SERVICE BULLETIN

CAPTURE OF POTENTIAL LOOSE FASTENERS ON INERTIA REELS

ATA 25-10-01

SB501583-25-01, Issue: 3
Page: 1 of 12
Date: 29-May-2018

Figure 1 – Dust Cover Fasteners

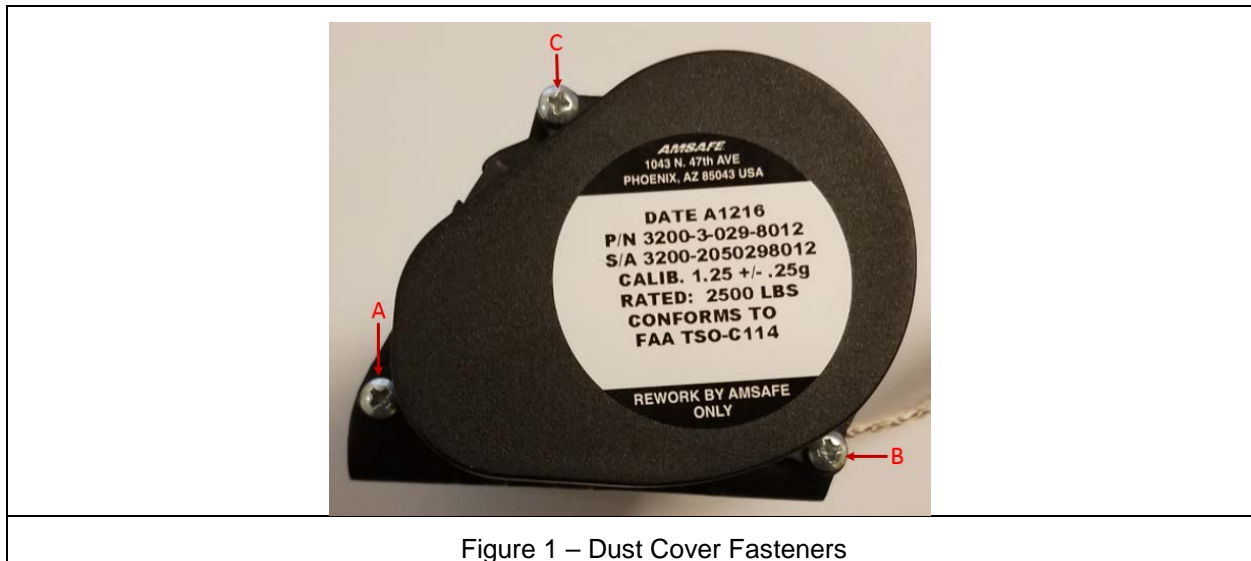
1. Identify the subject fasteners that hold the dust cover in place, as seen in Figure 1 below, indicated by letters 'A', 'B' and 'C'.

- Place a small strip of Torque Seal across each fastener and plastic dust cover attach points. Ideally, the strip should contact one metallic point on the frame, but it is not absolutely necessary for this Service Bulletin to be effective. Figures 2 and 3 show the Torque Seal applied.
